**Project: IEEE P802.15 Working Group for Wireless Personal Area Networks (WPANs)**

**Submission Title:** [DS-UWB Responses to TG3aVoter NO Comments]

**Abstract:** [Response to NO voter comments and feedback regarding the DS-UWB (Merger #2) Proposal]

# DS-UWB Has Less Aliasing

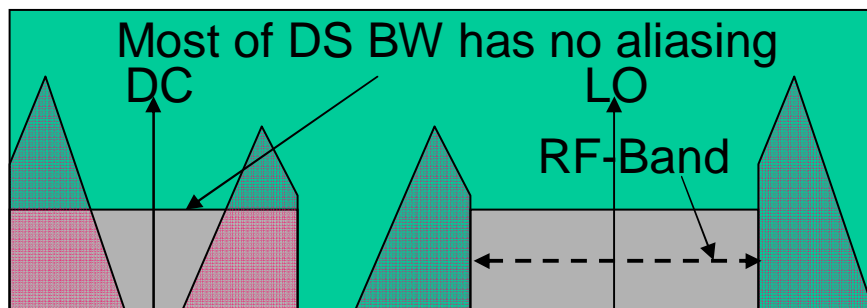
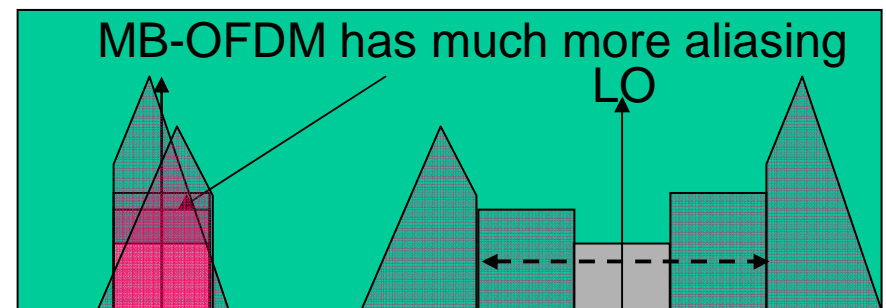
- Also, since there is no over-sampling proposed, it is easy for strong OOB signals to aliased into the 1.3 GHz wide passband. The degree of analog filtering necessary to protect such a system from alias bands has not been discussed. I would consider changing my no-vote to a yes, if the authors of merged proposal #2 could show their analysis of the order of filters required at baseband and at RF to achieve a 1m separation requirement from other unlicensed services in the UNII and ISM bands. Once the required filter orders have been established, we need to be convinced that such filters can be built on-chip with the required intrinsic bandwidth (1.3 GHz).

- Both proposals show direct conversion designs that will alias OOB signals into the ADC if they are not filtered out
- The lower the ADC sample rate, the worse the aliasing
  - This means that the MB-OFDM system is more susceptible
    - MB-OFDM has I & Q at 528 MHz (at more bit width)
    - Front-end filter does NOT remove aliasing terms from the MB-OFDM
      - Filter bandwidth is 3X wider the ADC/DSP bandwidth
      - RF-filter must let all hops through
      - Additional pre-ADC baseband filter required to remove multiple folds
  - Front-end filter DOES remove the aliasing terms from DS signal
    - DS has I & Q at 1.3 GHz (at less bit width)
    - Filter bandwidth matches ADC/DSP bandwidth
      - Can also use additional baseband filter, but is not absolutely required
